SURVEYOR'S OFFICE
Hamilton County

Re: Clara Knotts Drain, 103rd Street and Pennsylvania Street Intersection Reconstruction

Re: Clara Knotts Drain: 103rd St. & Pennsylvania St. Intersection Reconstruction

CITY OF CARMEL
 PENNSYLVANIA STREET IMPROVEMENTS
 AS BUILT PLANS
 PLAN & PROFILE
 LINE "A" - SHEET 1

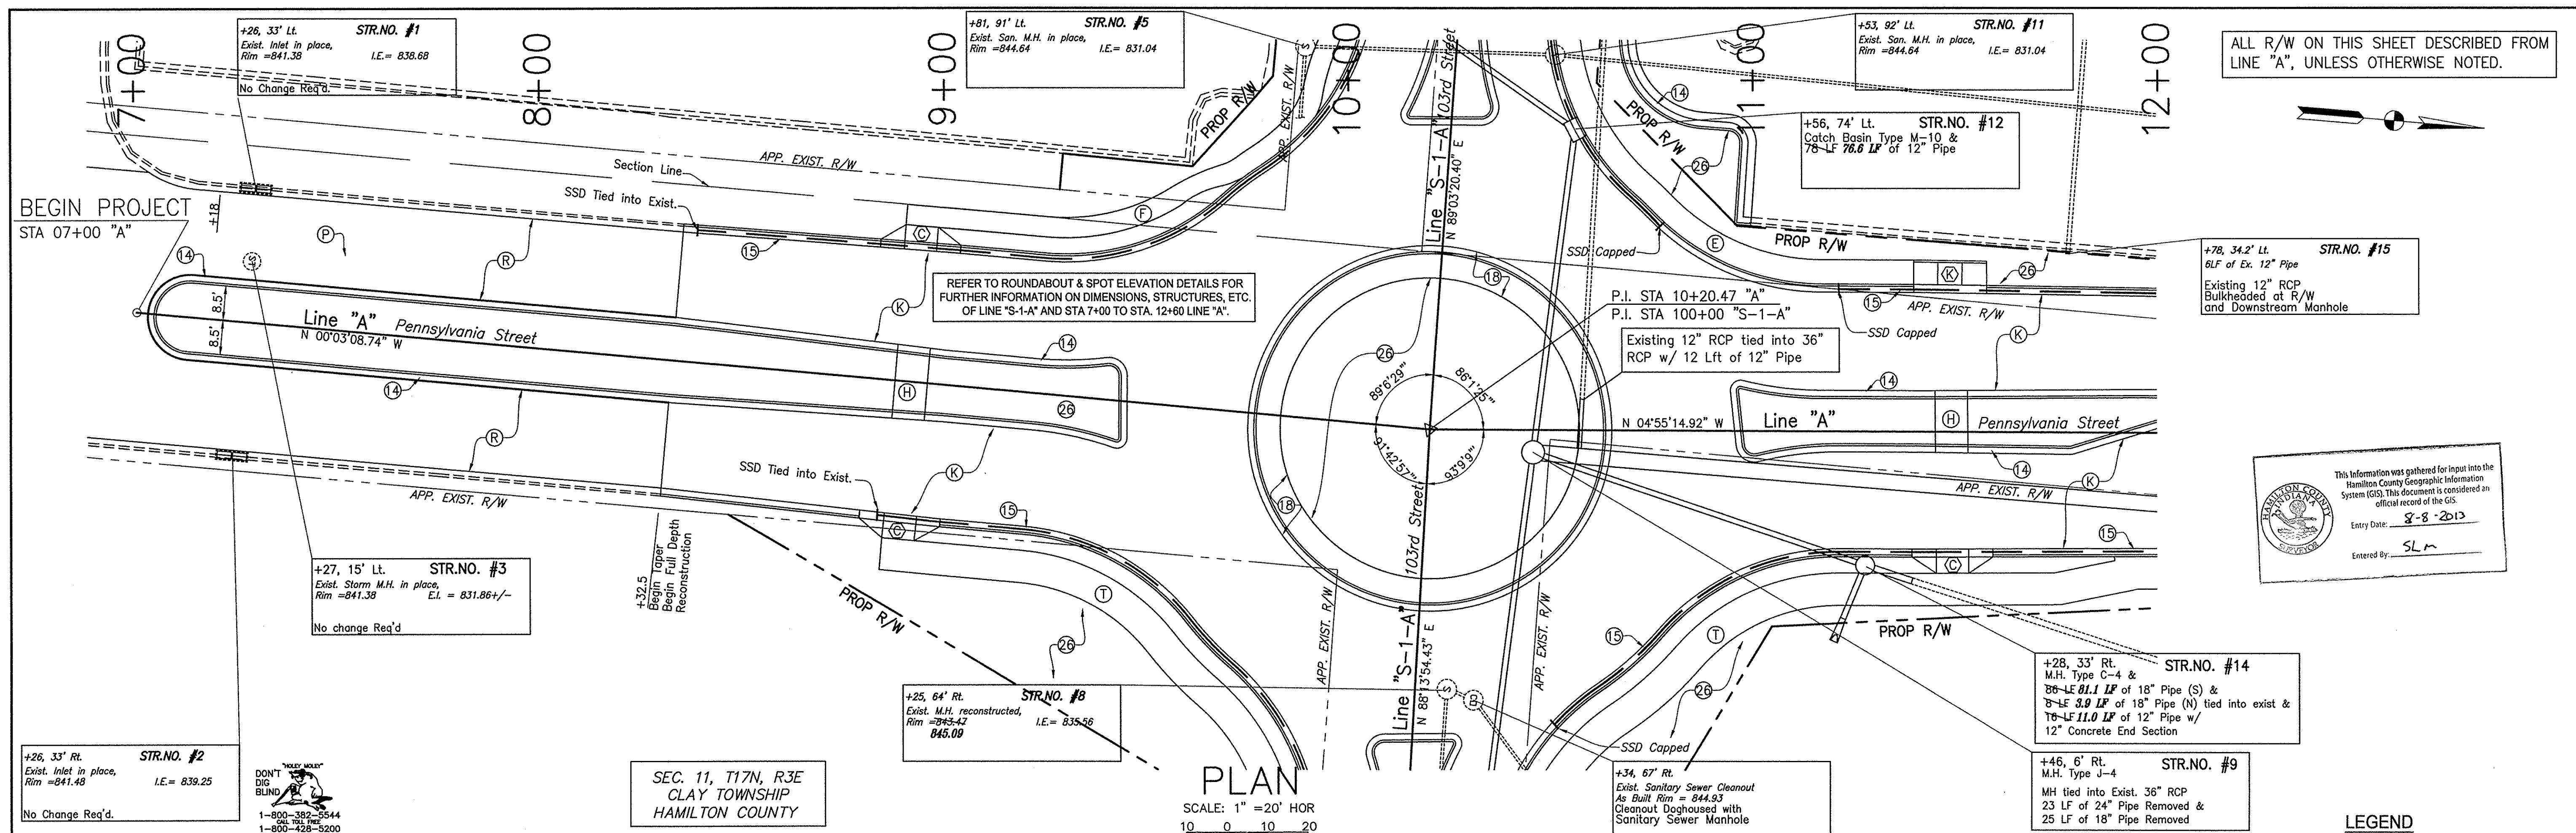
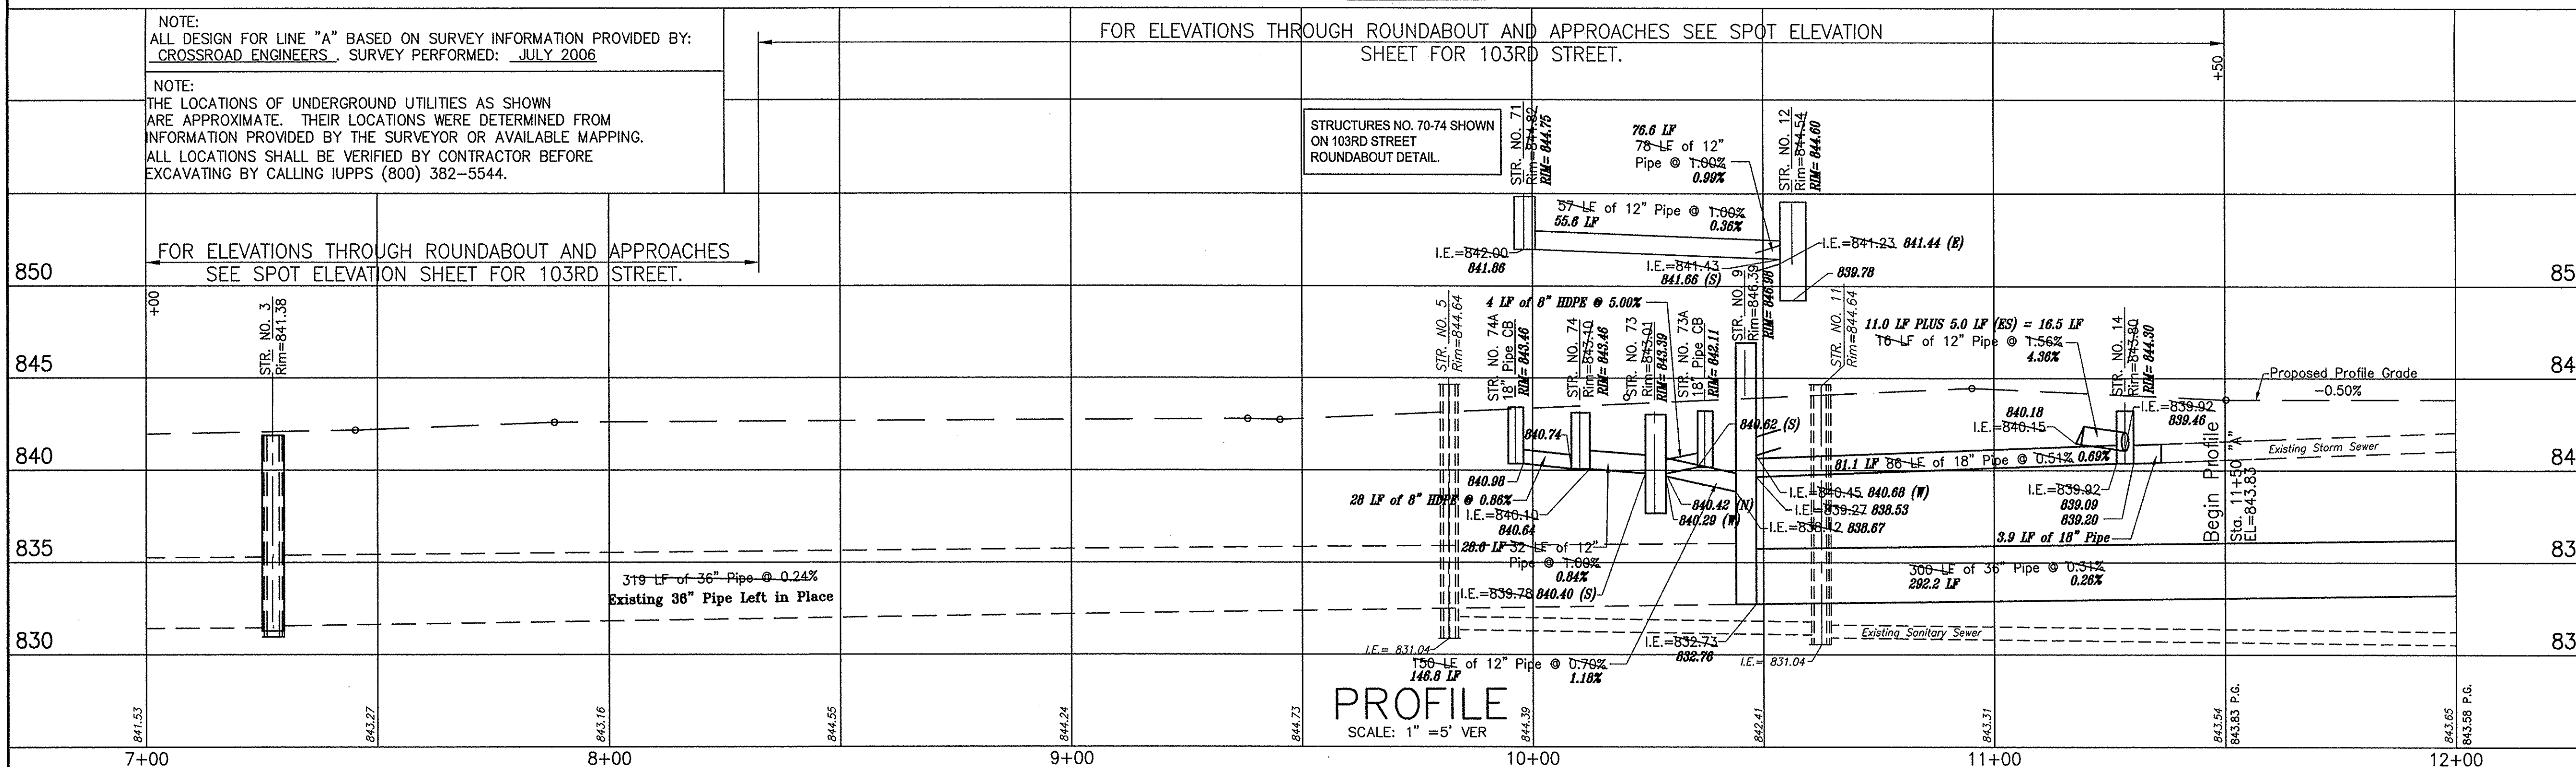
STR. NO. #8
 +25, 64' Rt.
 Exist. M.H. reconstructed,
 Rim = 845.42
 845.09
 I.E. = 835.56

STR. NO. #9
 +46, 6' Rt.
 M.H. Type J-4
 MH tied into Exist. 36" RCP
 23 LF of 24" Pipe Removed &
 25 LF of 18" Pipe Removed

STR. NO. #14
 +28, 33' Rt.
 M.H. Type C-4 &
 88-LF 81.1 LF of 18" Pipe (S) &
 8-LF 8.9 LF of 18" Pipe (N) tied into exist &
 76-LF 11.0 LF of 12" Pipe w/
 12" Concrete End Section
